August 9, 2022

Attention: Docket ID No. EPA-HQ-OAR-2020-0371

Re: *National Emission Standards for Hazardous Air Pollutants: Gasoline Distribution Technology Review and Standards of Performance for Bulk Gasoline Terminals Review: Proposed Rule*

Figure 1. Annual Average Benzene Concentrations at New Jersey Monitoring Sites

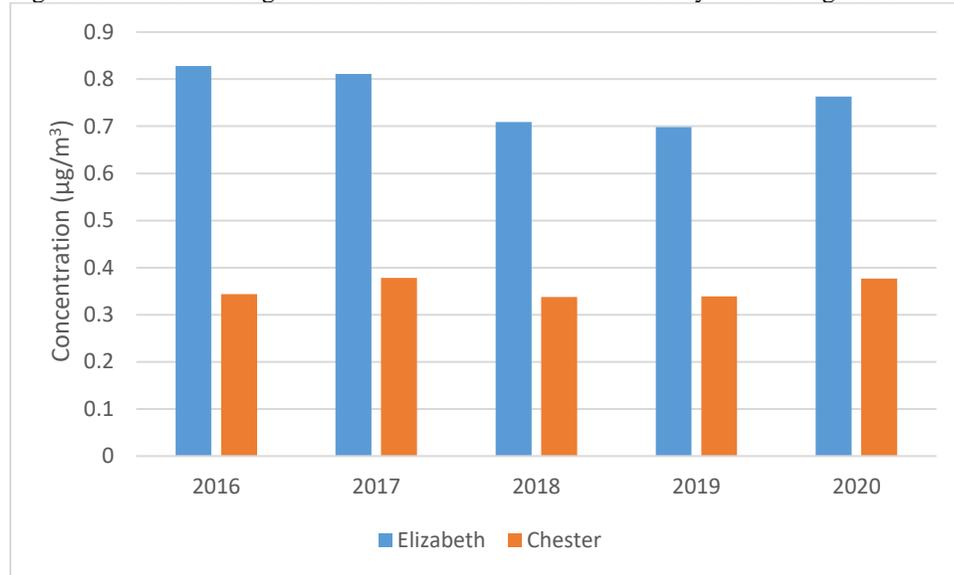
As shown in Figure 1, concentrations of benzene measured at the New Jersey Department of Environmental Protection (NJDEP) air monitoring site in Elizabeth, New Jersey, which is located in an area that has been designated as an Overburdened Community in accordance with

the New Jersey EJ Law [N.J.S.A. 13:1D-157],³ are on average, approximately twice those measured at the state’s background monitor in Chester, New Jersey. Although the higher benzene levels at the Elizabeth site are partially attributable to traffic on the nearby New Jersey Turnpike, several large bulk storage facilities located on both sides of the Turnpike also likely contribute to those elevated levels.

Figure 2. Weekly U.S. Regular Conventional Retail Gasoline Prices (Dollars per Gallon, Including Taxes)

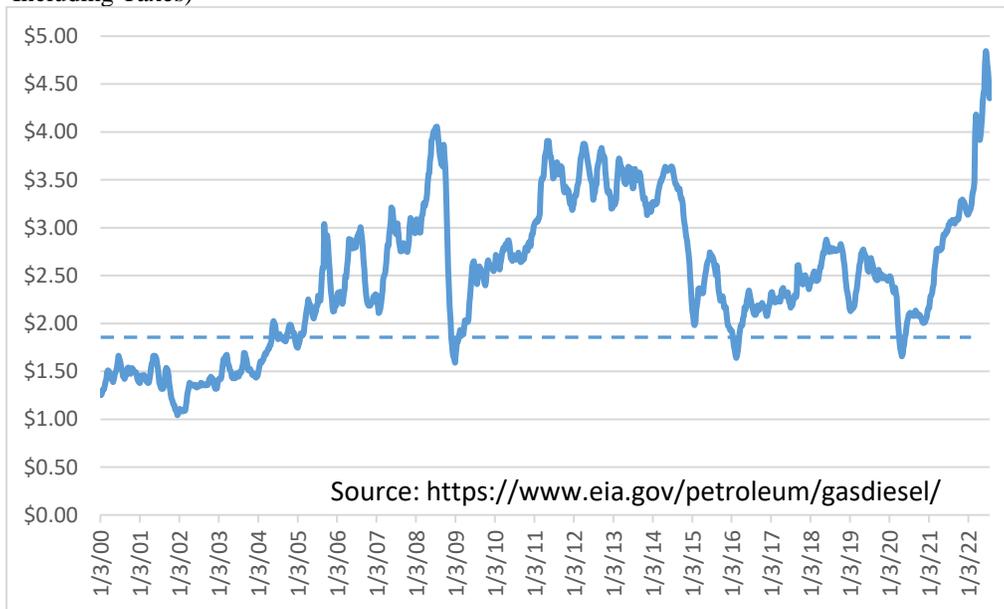
NESCAUM also believes the cost effectiveness evaluations may substantially underestimate the gasoline prices used to calculate credits associated with product recovery, even without consideration of recent price increases. The Proposed Rule states that EPA calculated gasoline prices from US Energy Information Administration (EIA) data as follows:

However, the EIA data referenced by EPA show that retail prices of regular conventional gasoline, with taxes included, have frequently risen higher than \$2.50 per gallon (including taxes), even before the 2021-2022 price increases, as shown in Figure 2.

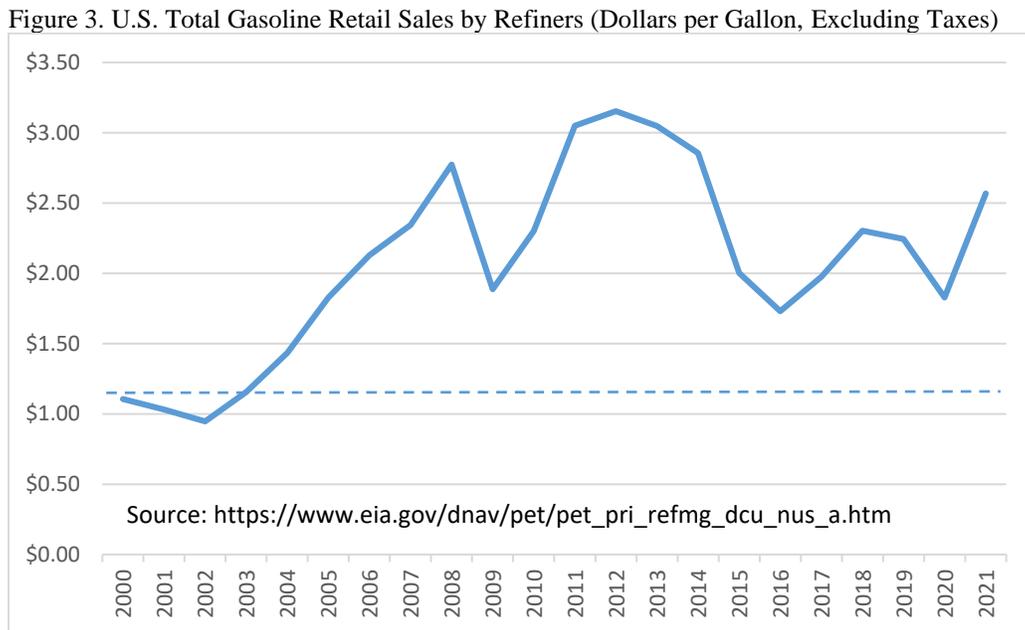
The Proposed Rule uses as further evidence a statement that EIA data show that, “(t)he average refiner’s wholesale spot price [which exclude taxes] for all gasoline types in 2019 was \$1.85/gallon.” [87 Fed. Reg. 35617, n. 4] As shown in Figure 3, those EIA data show that the refiner’s price for all gasoline types, excluding taxes, was higher than \$1.85/gallon in all but two years since 2000 and was higher than the \$1.50/gallon after-tax price used by EPA in the cost effectiveness calculations in all years in that period.

Any underestimation of the cost of gasoline would lead to an underestimate of the savings associated with product recovery, resulting in less favorable control option cost effectiveness calculations. This is a particular issue for the emission limit proposed for large area source bulk gasoline terminals, as the cost effectiveness index calculated using the \$1.50/gallon price for recovered product, as shown in Table 6 of the Proposed Rule, was \$12,170 per ton of HAP reduced for an emissions limit of 10 mg/L, which is considerably more stringent than the proposed limit of 35 mg/L. Use of a higher gasoline price would likely reduce the index for that option to below the threshold of \$10,000/ton of HAP that EPA uses in the Proposed Rule to identify cost effective controls.
